**CALIFORNIA COASTAL COMMISSION**

**RE:** Notice of Impending Development 2-97, Pursuant to the University of California Santa Barbara Certified Long Range Development Plan (LRDP) for Public Hearing and Commission Action at the meeting of March 12, 1998 in Monterey.

**SUMMARY AND STAFF RECOMMENDATION**

**EXHIBIT 3a**  
**UCSB NOID 2-97**  
**Site Plan**

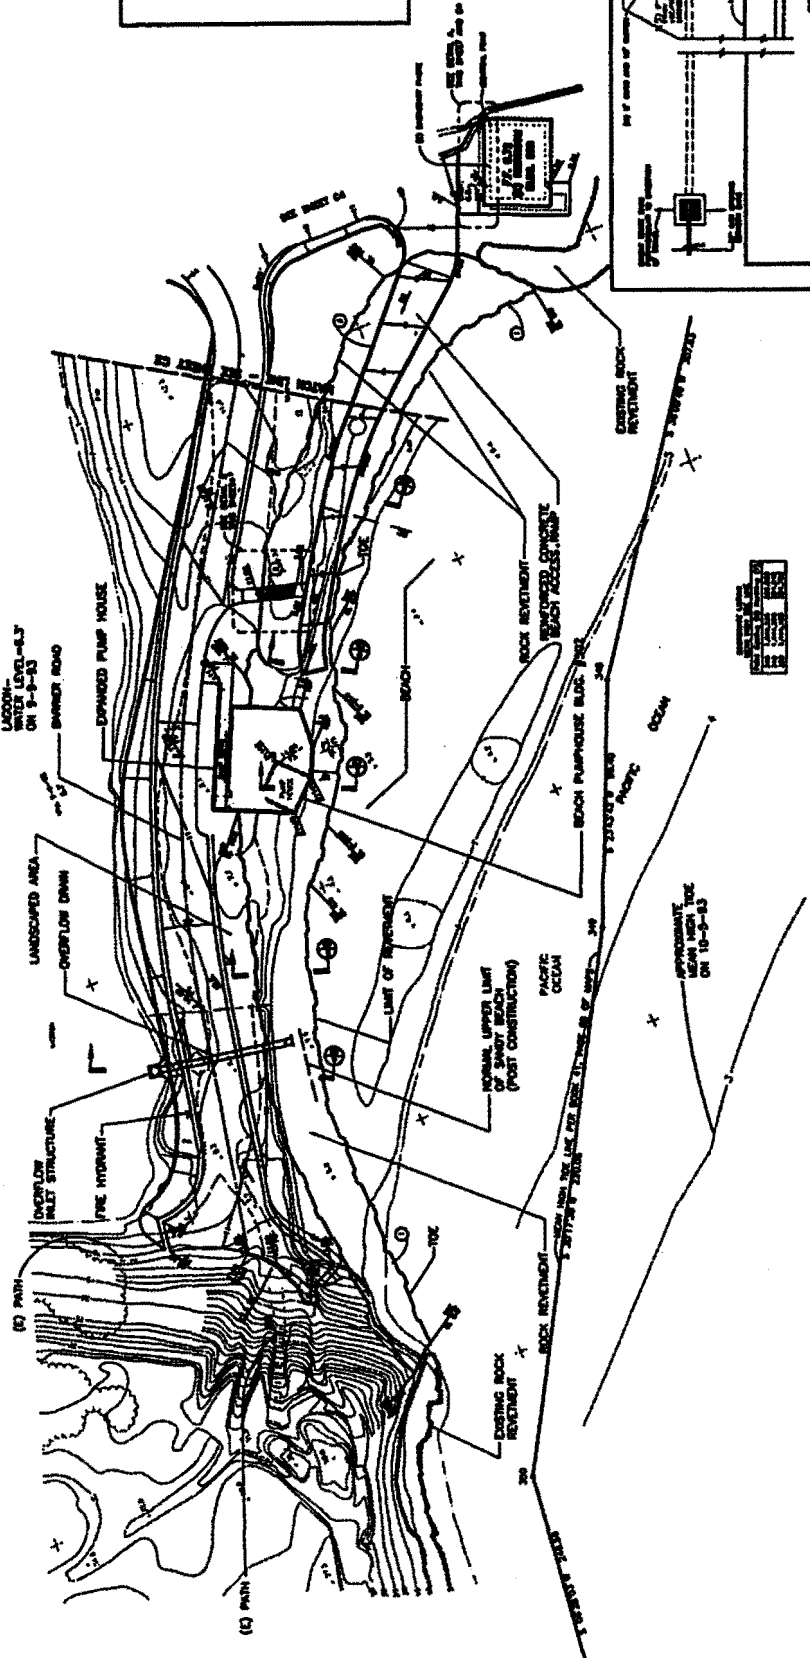
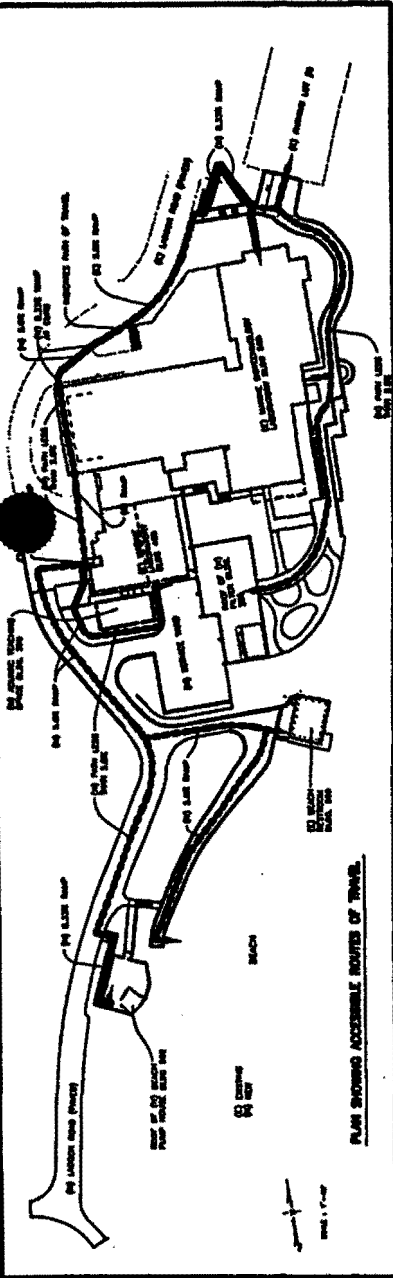
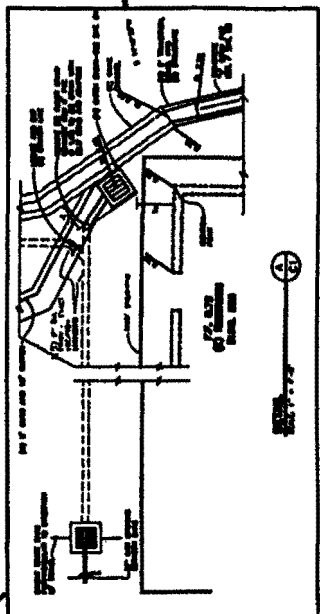
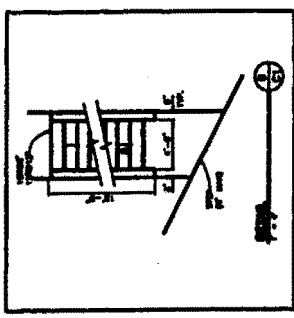
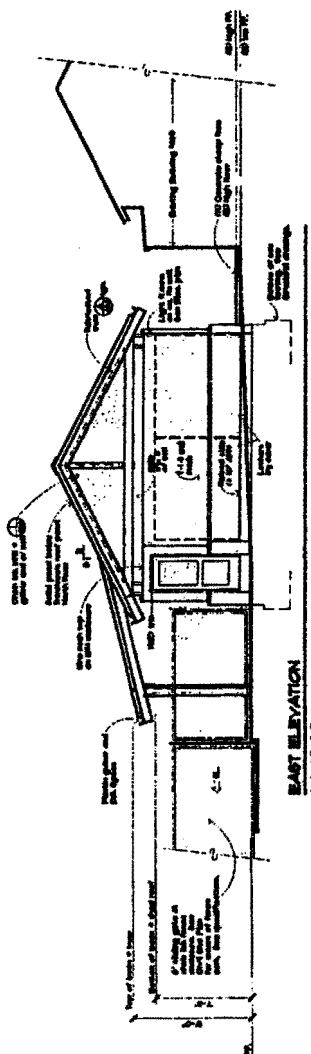
However, all improvements to the lagoon barrier will also be located within ESHA as designated by the LRDP. As stated previously, the improvements to the existing lagoon barrier involve grading, pavement of an access road across the barrier, construction of a turnaround at the terminus of the access at Lagoon Island, and landscaping. The entire project site, including the barrier itself and the sandy beach are designated as ESHA in the 1990 LRDP. The LRDP contains specific policies which require the protection of wetland and ESHA areas. For example, LRDP policy 30233(a)1 states

Although pavement of the access road in its present configuration and the construction of a turnaround will not adversely impact sensitive habitat, the proposed grading of the barrier will result in the filling of 0.01 acre of the lagoon wetlands and has been identified in the Environmental Impact Report submitted for this notice as a significant impact. In addition, the pavement of an access road atop the proposed 700 cu. yds. of fill would constitute the construction of a new, or reconfigured, road across the lagoon barrier. Although the amount of fill which will impact the Lagoon wetlands is minimal and the University has proposed 1:1 replacement mitigation in the Environmental Impact Report submitted for this notice, the

Commission notes that this activity is not consistent with LRDP policy 30233(a)1. As such, the placement of fill in order to increase the height of the lagoon barrier and construct a new road is not consistent with the applicable habitat protection policies of the LRDP. In addition, the Commission notes that the placement of fill along the barrier is integrally related to the construction of a rock revetment (proposed as part of the related LRDP Amendment 2-97 and Coastal Development Permit 4-97-156) which would also result in significant impacts to the beach ESHA. As such, the placement of fill to increase the height of the lagoon barrier is only necessary in conjunction with the proposed rock revetment. Further, the placement of fill in order to increase the height of the lagoon barrier is not consistent with Part 2, Chapter VI, Section D of the 1990 LRDP as recommended by modification one of LRDP Amendment 2-97 which would prohibit the placement of fill in order to increase the height of the existing lagoon barrier. Therefore, special condition two (2) has been required in order to ensure that the proposed improvements to the lagoon barrier do not include the placement of fill that would increase the height of the barrier.

However, this notice also includes improvements to the existing lagoon barrier. These improvements involve the placement of approximately 700 cu. yds. fill to raise the height of the barrier from approximately 8 ft. mean sea level (MSL) to approximately 11 ft. MSL, pavement of an access road across the barrier, construction of a turnaround at the terminus of the access at Lagoon Island, and landscaping. The University has submitted information confirming that the average sandy beach elevation at the barrier is approximately 5 ft. above MSL. As the lagoon barrier now exists, beachgoers may easily access the sandy beach from any point along the approximately 400 ft. long barrier road with only an approximate change in elevation between the road and the beach of 3 ft. The beach within the project area is backed only by the low artificial lagoon barrier rather than the high bluffs characteristic of the surrounding coastline and, thus, constitutes a natural access point for beachgoers. In addition, the beach within the project area serves as one of only two vertical public access points to the sandy beach between Goleta Point and Goleta Beach. The other public access point, an existing stairway from the blufftop located approximately 1,100 ft. to the north of the project area, has been closed by the Campus for safety reasons.

Although pavement of an access road in its present configuration and the construction of a turnaround will not adversely impact public access, the placement of 700 cu. yds. of fill in order to raise the height of the revetment to 11 ft. MSL will create a difference in elevation between the access road and the sandy beach (sand elevation is approximately 5 ft. MSL at the lagoon barrier according to University information) of approximately 6 ft effectively restricting or eliminating public access to the sandy beach. In addition, the pavement of an access road atop the proposed 700 cu. yds. of fill would constitute the construction of a new, or reconfigured, road across the lagoon barrier. As such, the placement of fill in order to increase the height of the lagoon barrier and construct a new road is not consistent with the applicable public access policies of the LRDP. In addition, the Commission notes that the placement of fill along the barrier is integrally related to the construction of a rock revetment (proposed as part of the related LRDP Amendment 2-97) which would also result in significant impacts to public access to and along the beach which is located within public tidal lands. The placement of fill to increase the height of the lagoon barrier is only necessary in conjunction with the proposed rock revetment. Further, the placement of fill in order to increase the height of the lagoon barrier is not consistent with Part 2, Chapter VI, Section D of the 1990 LRDP as recommended to be modified by modification one of LRDP Amendment 2-97 which would prohibit the placement of fill in order to increase the height of the existing lagoon barrier. Special condition two (2) has been required in order to ensure that the proposed grading does not interfere with public access to the sea.

Prior to the commencement of development, the University shall submit, for the review and approval of the Executive Director, revised plans prepared by a qualified civil engineer which eliminates the placement of fill which would increase the height of the existing lagoon barrier above its present elevation.
